To:		From:	Kevin Armstrong
Company:	Nuclear Regulatory Commission	Date & Time:	1-25-02
Fax Number:	301-816-5151	Pages:	10
Subject:	U02O3FBBR-**

The attached analysis indicates a potential 10 CFR Part 21 reportable problem with Automatic Valve part number U02FFBBR-**

AUTOMATIC VALVE TITLE: CORRECTIVE ACTION SUBJ: CORRECTIVE ACTION	NUMBER: D7174-003 LOCN: I:\WORD\DOCUMENT\07174003.DOC TYPE: FORM	PAGE 1 OF 9 DATE: 10-21-1999 REV: F-CN8020
--	--	--

Figure 1A - Normally Closed Mode

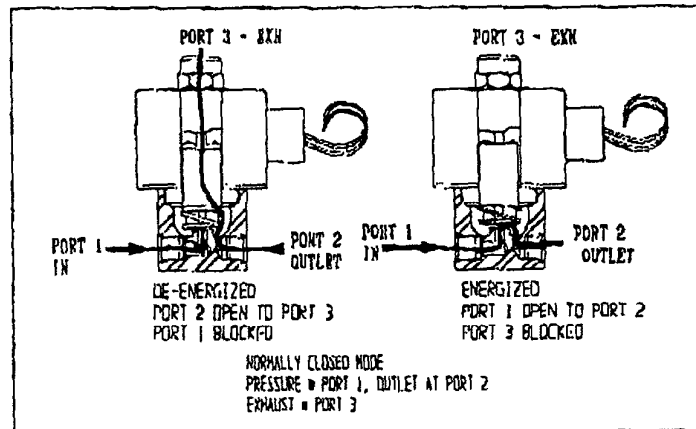
1. A faulty valve will leak out of port 3 when the valve is used in its normally closed mode as shown in Figure 1A or leak out of port 1 when the valve is used in its normally open mode as shown in Figure 1B.

5. There is a concern that U0203FBBR-** valves used in the normally closed mode will not return to their de-actuated position if the valve has been in its de-energized position for a sufficient amount of time for the valve and the internal top seal to cool down. If the valve is energized then is de-energized, within a period of approximately 60 minutes with 125 psig at port 1, or 15 minutes with 80 psig at port 1 there is a high probability that the valve will not return to its de-energized condition.

Figure 1B - Normally Open Mode

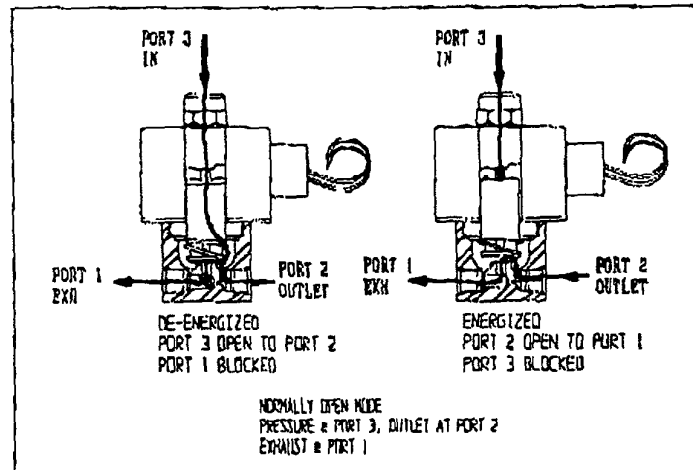
2. There is no concern that U0203FBBR-** valves used in the normally open mode (pressure at port 3) will return to their de-actuated position (port 3 open to port 2 and port 1 blocked) when the solenoid is de-energized. In this mode both the internal spring, the external spring, and inlet pressure at port 1 act to return the plunger to its normal de-actuated position.

Figure 3A - Plunger in De-Energized Position

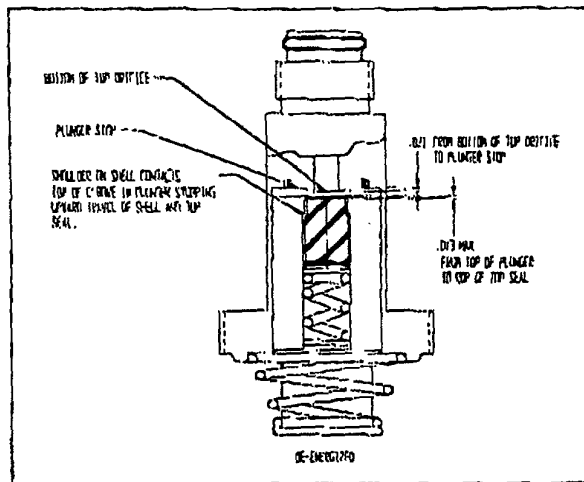
When the valve is in its de-energized state, upward travel of the top seal and its containment shell is stopped when the shoulder of the shell contacts the top of the counter-bore in the plunger as shown in Figure 3A. In this de-energized position, the top seal is within a maximum distance of .013" from the top surface of the plunger. When the valve is energized, the top of the top seal first contacts the bottom of the top orifice as shown in Figure 3B. At this point further upward motion of the top seal and shell stops. The plunger continues its upward travel until the top of the plunger contacts the plunger stop as shown in Figure 3C. Because upward motion of the top seal and shell stops when the top seal contacts the top orifice, the additional upward motion of the plunger compresses the internal spring by the distance the plunger travels after the seal contacts the orifice - approximately .008. (Refer to Figure 4 for a detailed view showing the shell and plunger in the energized position.)

Figure 4 – Enlarged view of top seal and shell in the energized position.

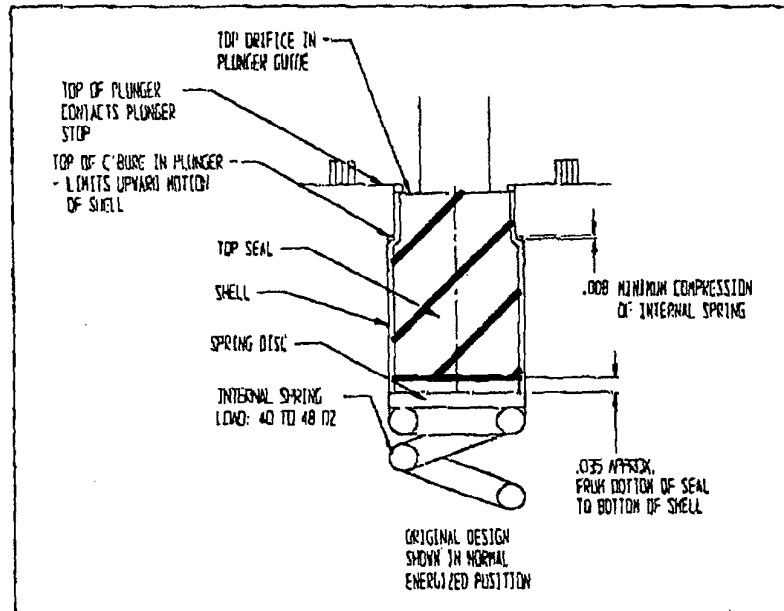
1. The bottom of the containment shell is not flush with the bottom of the top seal as shown in Figure 4. Consequently, the spring force generated by the internal spring, and transmitted through the disk, acts only on the bottom of the shell. Because the top of the seal is in contact with the top orifice it cannot move further upwards. The force acting to counter the internal spring force exerted on the bottom of the shell to keep the shell in place relative to the top seal is the friction force between the shell and the seal as shown in Figure 6.

The shell retaining the top seal has been redesigned so that bottom of the shell is flush with the bottom of the top seal. By changing the design of the shell in this manner, the force exerted by the internal spring and transmitted by the disk, acts on both the bottom of the shell and the bottom of the seal. Because the force now acts equally on both components, there is no force acting on the bottom of the shell tending to move it upwards with respect to the top seal. (Refer to Figure 7.)

Figure 5 – Pressure Drop

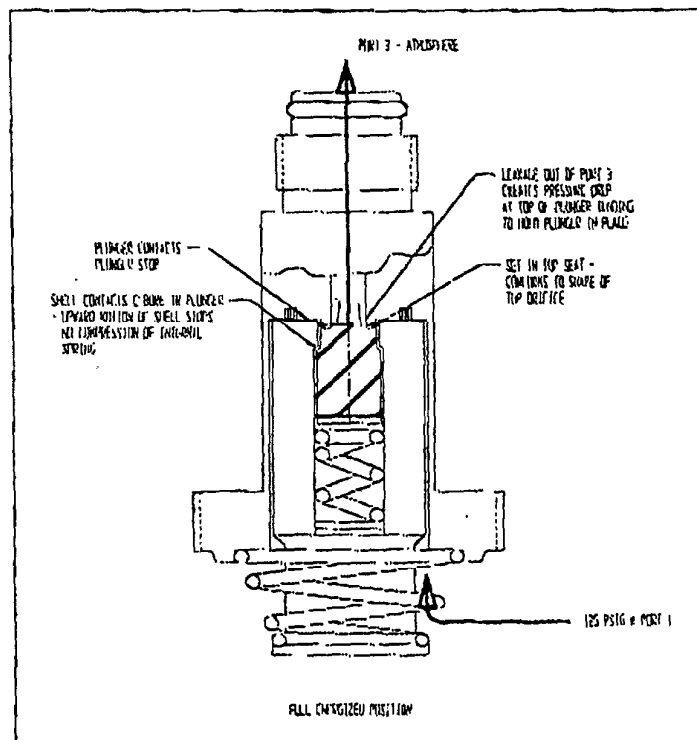
When this happens, the top seal is touching the top orifice but is not compressing the internal spring sufficiently to create a good seal and leakage occurs out of port 3. As the leak intensifies, it creates a pressure drop at the top of the plunger as shown in Figure 5. The greater the leak, the greater the pressure drop. At leak rates less than 60 SCFH, all plungers returned.
